Responses to NRC Requests for
Additional Information Dated
February 12, 2016
Sweetwater Uranium Project
Docket Number: 40-8584
Source Material License SUA-1350

**Responses to NRC Requests for Additional
Information Dated February 12, 2016
Sweetwater Uranium Project
Docket Number: 40-8584
Source Material License SUA-1350**

Prepared by
**Telesto Solutions Inc.
3801 Automation Way, Suite 201
Fort Collins, Colorado 80525**

Figure 1 2015 Contaminant Bounds from Historical Releases

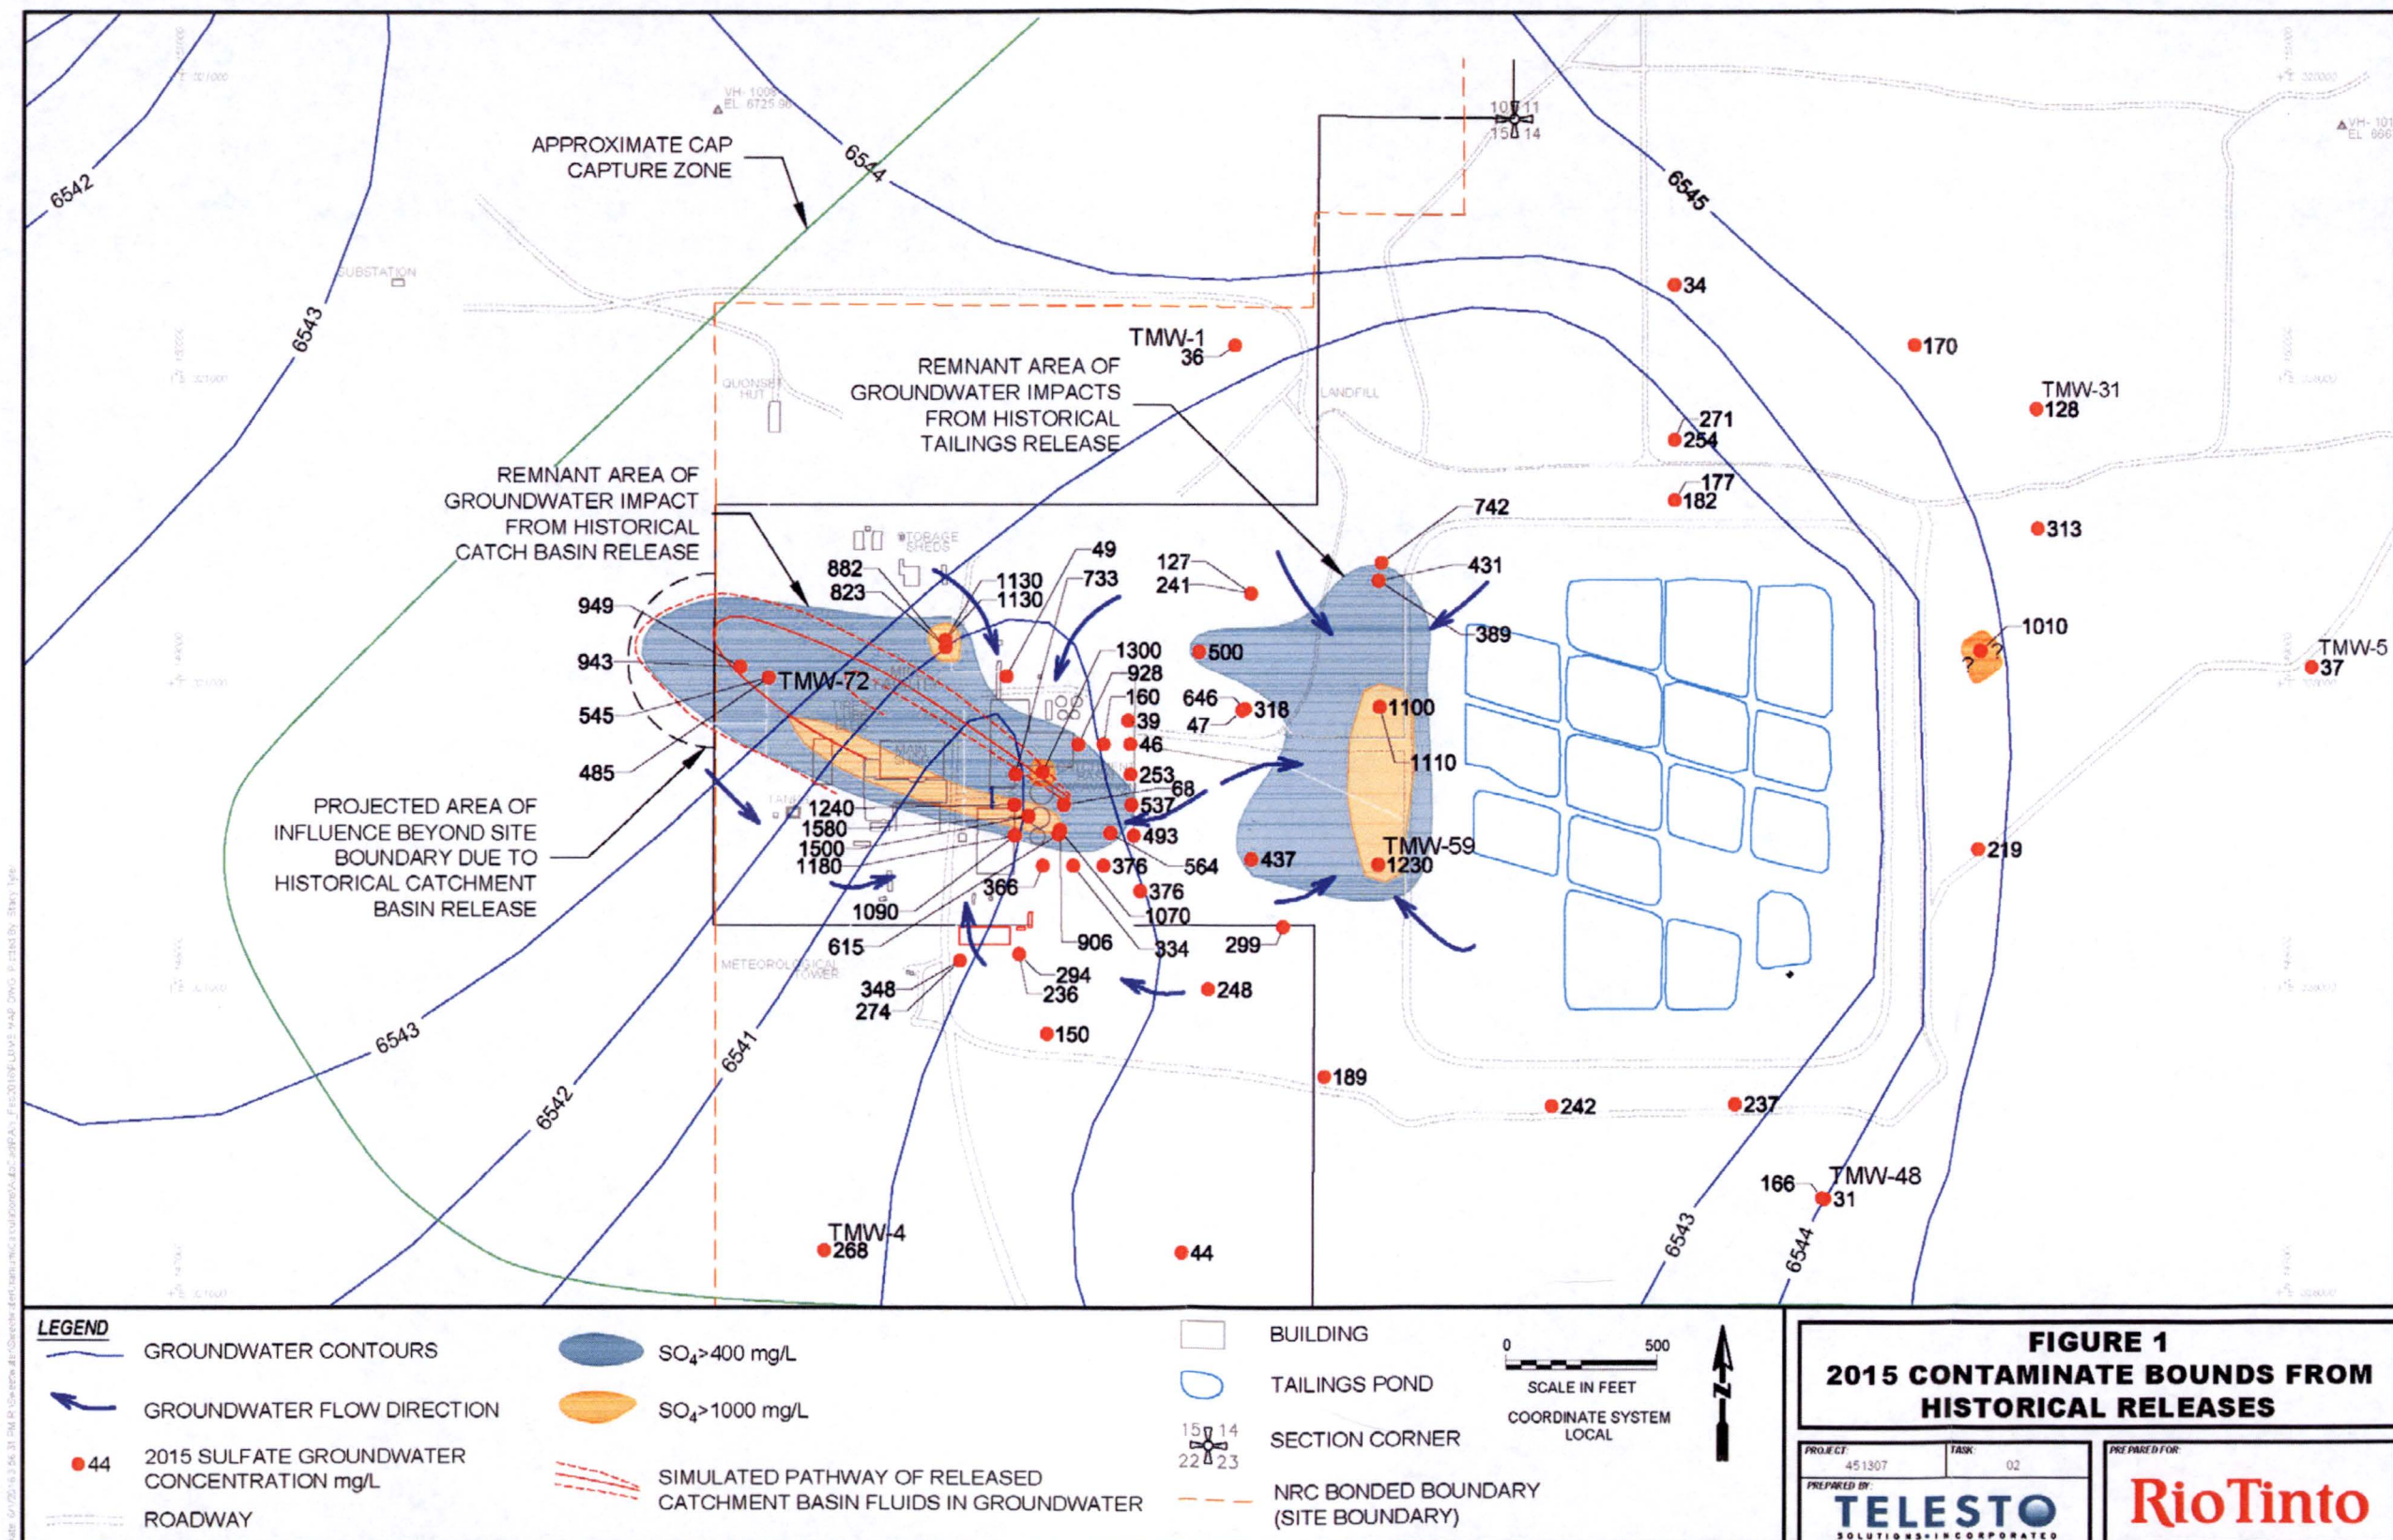
For the environmental impacts on water resources provide the following: a) is the current contamination discussed in (KUC, 2014) from i) an existing leak, ii) a previous leakage that has been repaired, or iii) a combination of (i) and (ii)?; and iv) if the answer for (a) is (a,ii) provide the technical basis as to why the contaminants have not been contained for more than 30 years since the leakage from the tailings impoundment synthetic liner was repaired in 1984, despite that a Corrective Action Program is in place to contain the contamination; b) address impacts of contaminants leakage on surface water and ground water resources for i) standby mode, and ii) future operation mode as more contaminants will be generated; c) address spread of the contaminants discussed in (KUC, 2014) beyond the site boundary including the

following: i) impacts on surface water resources, ii) impacts on ground water resources, iii) monitoring measures, and iv) mitigation measures.

Figure 1 provides a synopsis of the current groundwater impacts from the historical tailings and catchment basin releases. The area of influence from the tailings release is contained beneath the tailings impoundment footprint and extends to the west approximately 500 feet. The area of influence from the catchment basin release is currently projected to extend approximately 250 feet west of the site boundary (defined as the NRC bonded area boundary). There is a **chance** that some of the fluids have migrated beyond the NRC's bonded area boundary. KUC has put forth a plan (Telesto, 2015b) to the NRC to characterize this potential and is awaiting concurrence. Depending on the results, KUC is committed to expanding the CAP to ensure continued containment should it be determined that remnant process fluids have traveled beyond the current CAP influence.

Telesto (2009) describes the contaminant fate and transport mechanisms that resulted in the distributions shown in Figure 1. No surface waters exist in the vicinity and therefore, no impacts to surface waters have taken place due to the historical releases from the catchment basin and tailings.

KUC will continue to monitor groundwater throughout its operational boundary irrespective of operational status. The spot sulfate concentrations shown in Figure 1 are an example of recent monitoring efforts. KUC has proposed to extend the monitoring system to the west of the site boundary in order to determine if effects from catchment basin seepage are within the projected area of influence as shown in Figure 1, and is awaiting NRC concurrence with the plan.

The CAP, approved by the NRC, is the mitigation measure implemented by KUC to contain both the tailings and catchment basin releases. The primary component of the CAP is hydraulic containment, which (based upon existing measurements and groundwater simulations) appears to be functioning as planned. Figure 1 shows the current capture zone of the CAP system.
